ARCHITECTURAL REVIEW BOARD REGULAR MEETING AGENDA

Herndon Council Chambers Building
765 Lynn Street, Herndon, VA 20170

Wednesday, January 21, 2026 | 7:30 PM

ARB #25-005 – Alteration to an Existing Structure

Design Change

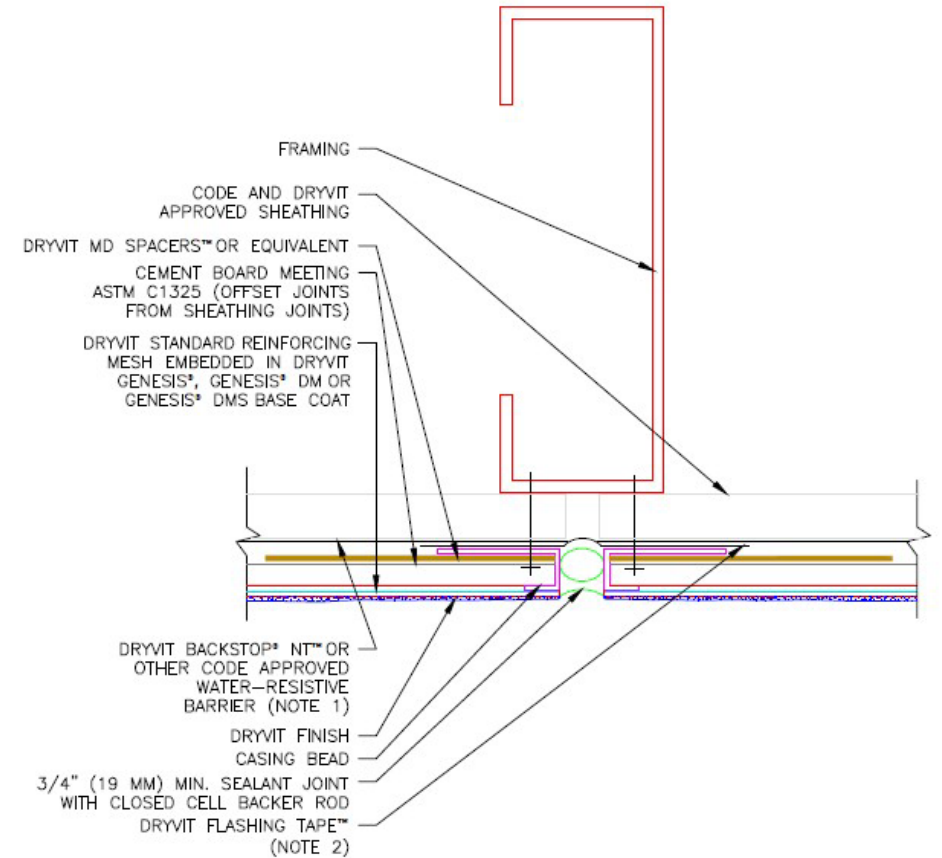
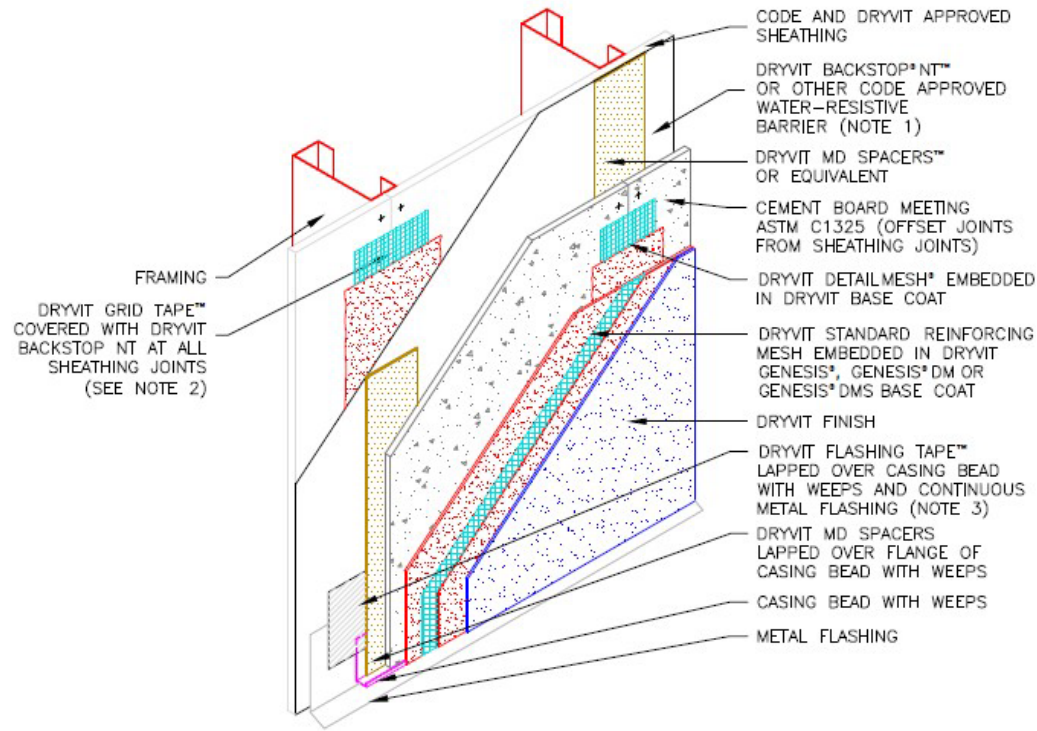
- Work Session:
 - Board acknowledged EIFS generally not a desirable material
 - Stated EIFS may be appropriate as already used on façade
 - Board asked if green roof can be maintained
- Applicant requested to continue their application to the February ARB meeting cycle
- Staff are requesting:
 - Applicant provide a material sample of EIFS at the next ARB meeting
- Staff recommend continuance, as requested by the applicant
